APPLICATION NUMBER: RECON 25/0924

PROPOSAL: CONSTRUCTION OF AN OFFICE CENTRE (B1) AND ASSOCIATED WORKS

SITE: Land To North Of Phoenix House Buchanan Way Newport

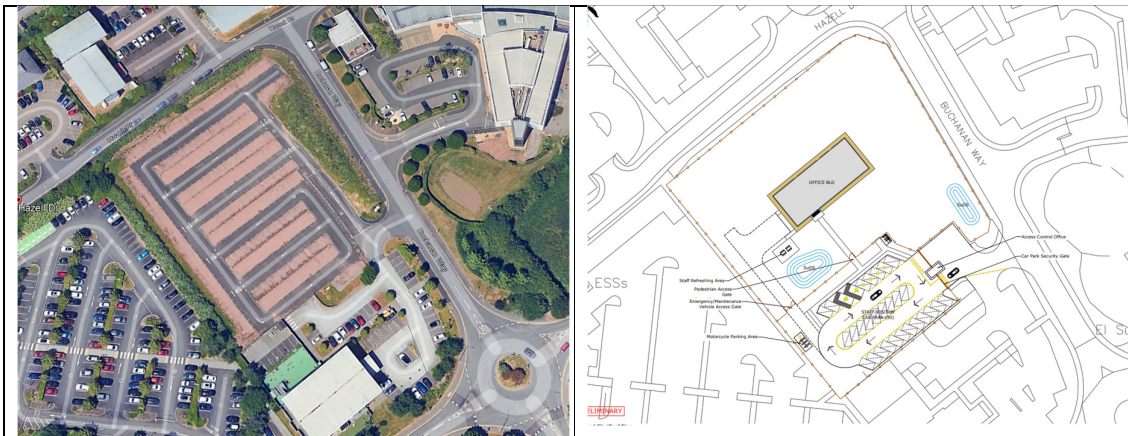
3. The character of the vegetation shown as retained along the north boundary onto Hazell Drive is still unclear - there is no description of this – see photo below which shows bramble dominating and an issue onto the public footpath. Please advise on what the vegetation composition is and how this will be managed.
